Title: **STAGE 1 ROAD SAFETY AUDIT**

**Proposed Mixed Use Development, Swords Road, Santry,
Dublin 9.**

Client: **DBFL Consulting Engineers.**

Report reference: **2173R01**

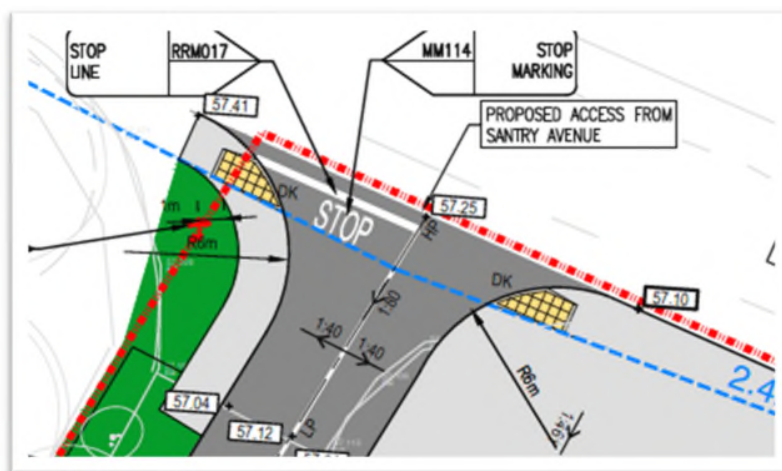
The proposed vehicular access off Santry Avenue is opposite an on-road bus stop (Route 17A) which is currently slightly built-out from the through kerb line. Drivers may exit from the proposed development when other drivers are overtaking parked buses which could lead to head on-or side swipe collisions.

Ensure that the proposed access does not compromise the safety of road users when buses are stopped on Santry Avenue. This may require the relocation of the bus stop.

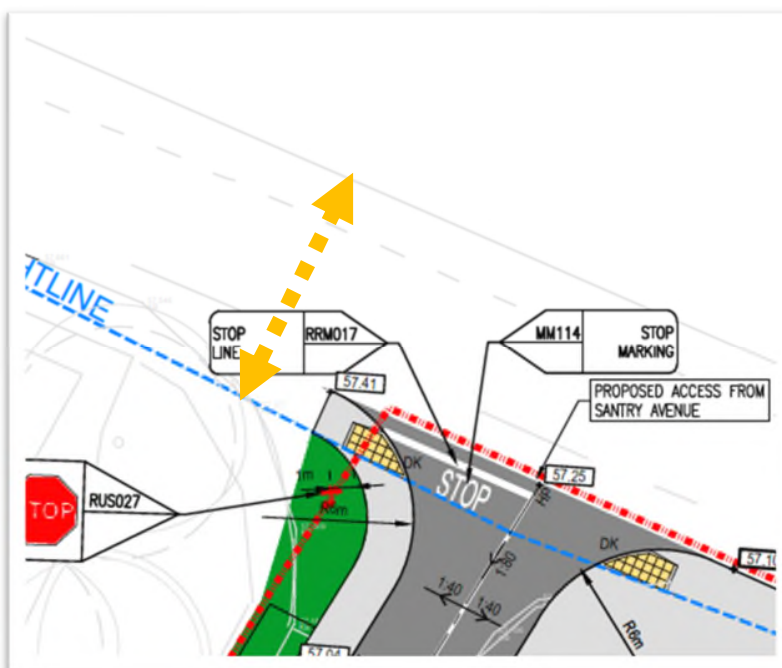
There is an existing controlled pedestrian crossing on Santry Avenue immediately west of the proposed vehicular access to the development. There is a risk that drivers exiting the development and turning left might not see the red signals and may turn at the same time as a pedestrian starts to cross the carriageway leading to a possible collision.

It is recommended that the existing crossing and signals be assessed for visibility by exiting drivers. If insufficient visibility is provided then the crossing or the access should be relocated.

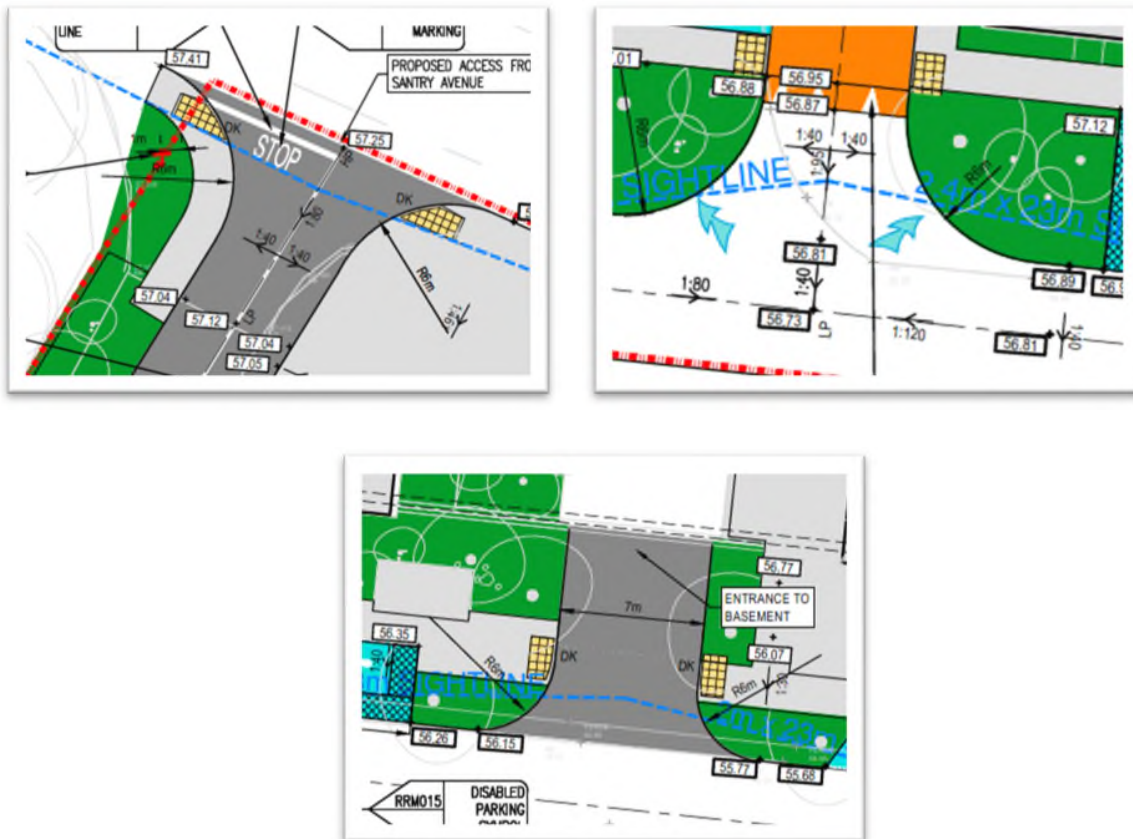
It is proposed to have 6m corner radii at all the vehicular accesses including the basement access. Larger corner radii can lead to higher turning speeds, greater distances for pedestrians to cross and greater likelihood of turning drivers not being able to see cyclists. Larger radii therefore lead to higher likelihoods and severity of collisions with vulnerable road users.

It is recommended that suitable corner radii be provided.
